ADDENDUM NO. 1

DATE: January 27, 2014

Contract 13-C-00042; Downs Pumping Station Rehabilitation – Sheltered market

Downs Pump Station Location

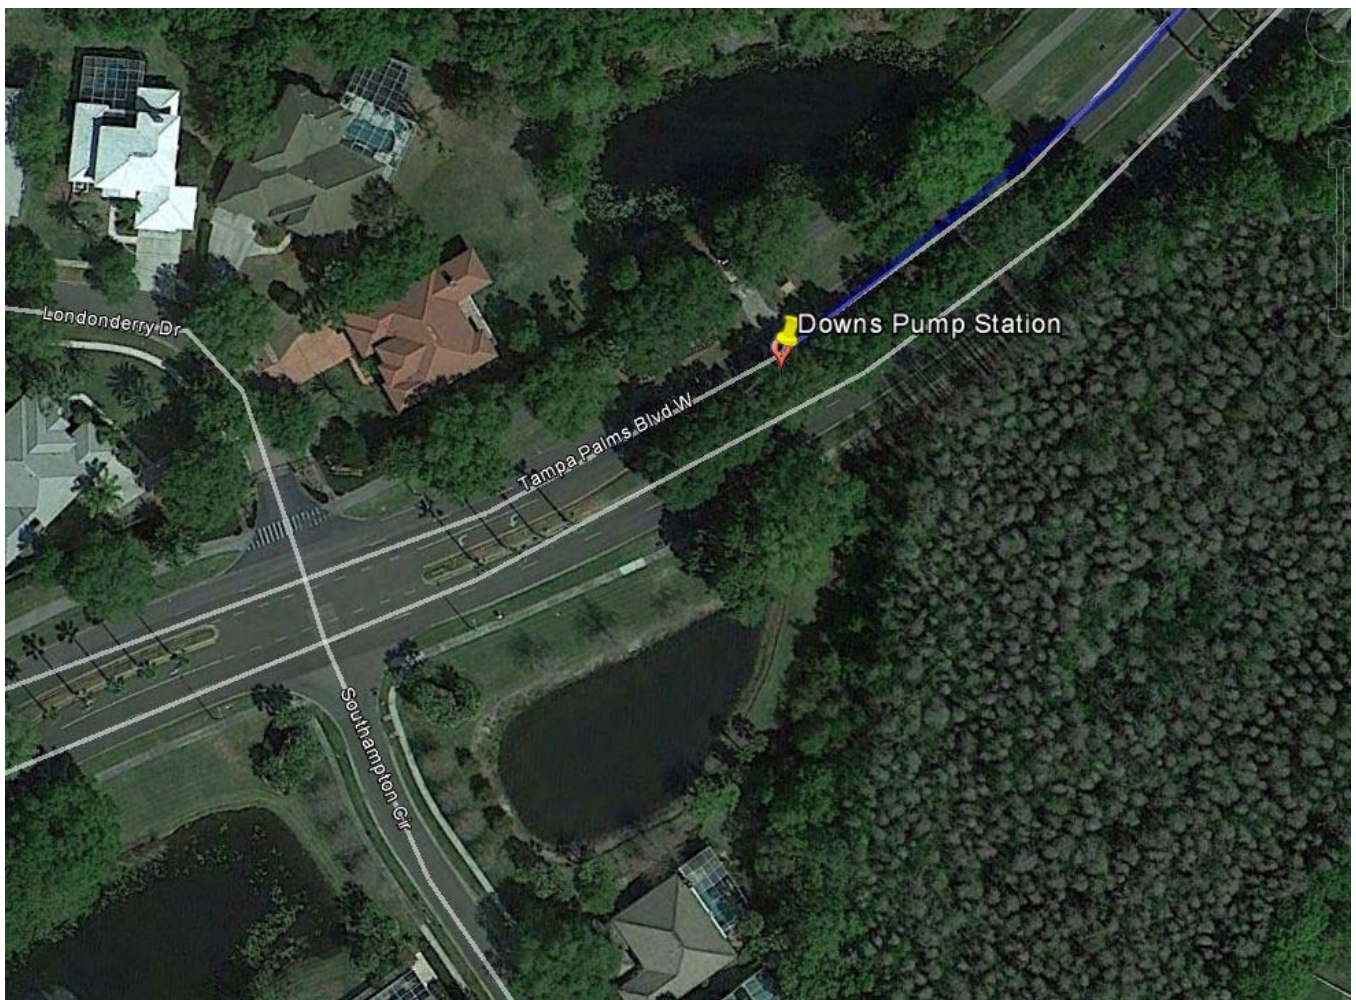
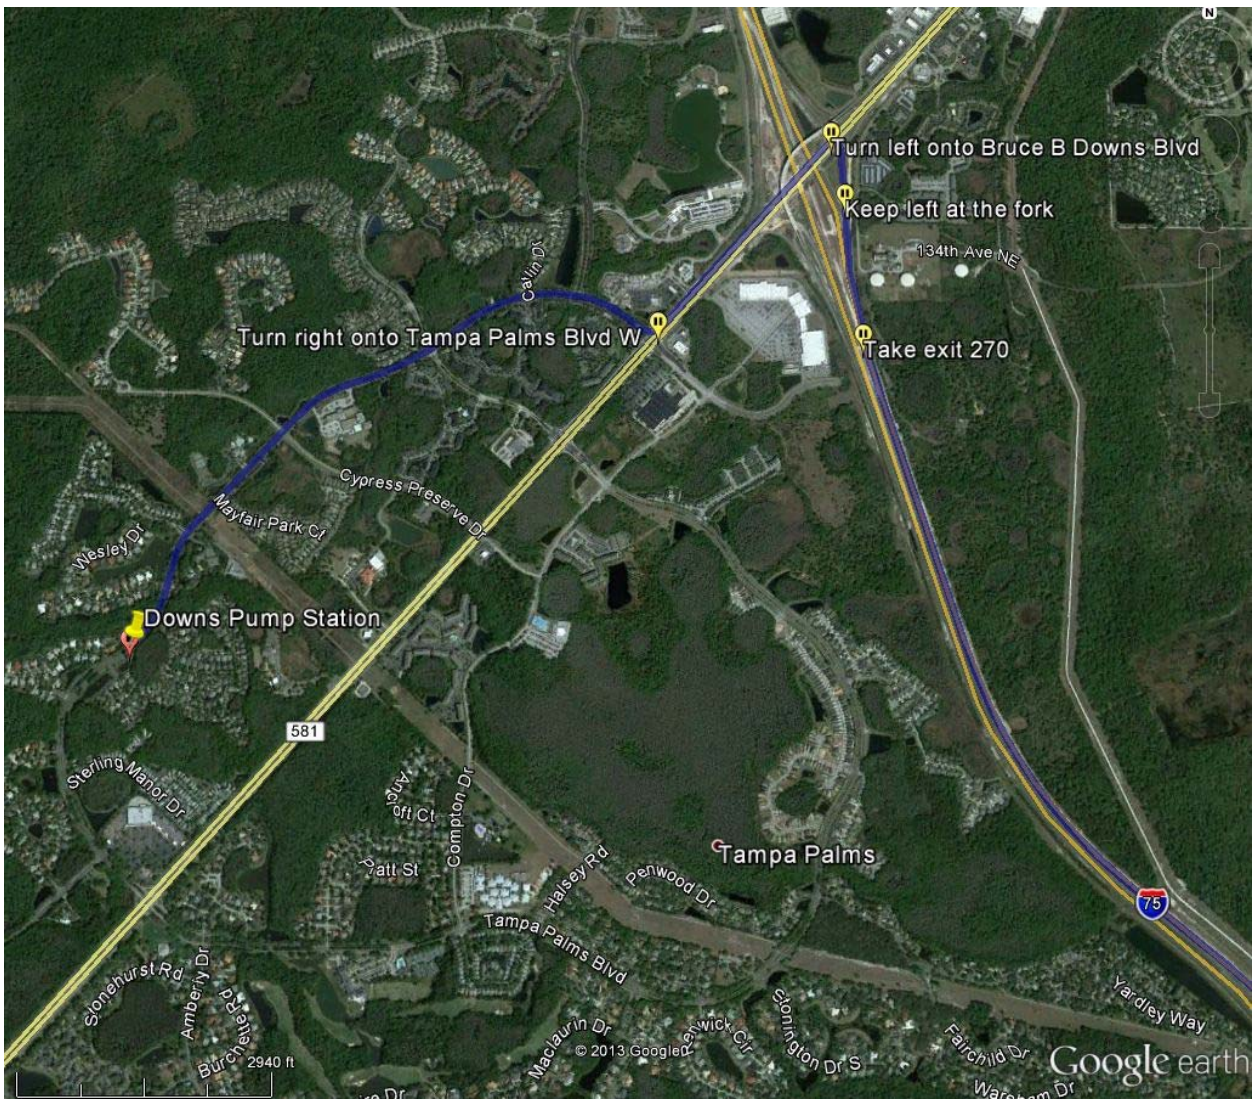
- Item 1: Pump Station location clarification: the address listed in the bid documents is incorrect. Refer to the attached maps for the correct pump station location.
- Item 2: Replace Workmanship and Materials Sub-section 46.09 Sewage Pump Controller/SCADA/Radio (PCSR) with the attached, revised Workmanship and Materials Sub-section 46.09
- Item 3: Replace Plan Sheets E11 and E14 with the attached, revised plan sheets E11 and E14.

Tampa Palms Blvd W, East of Londonderry Dr.
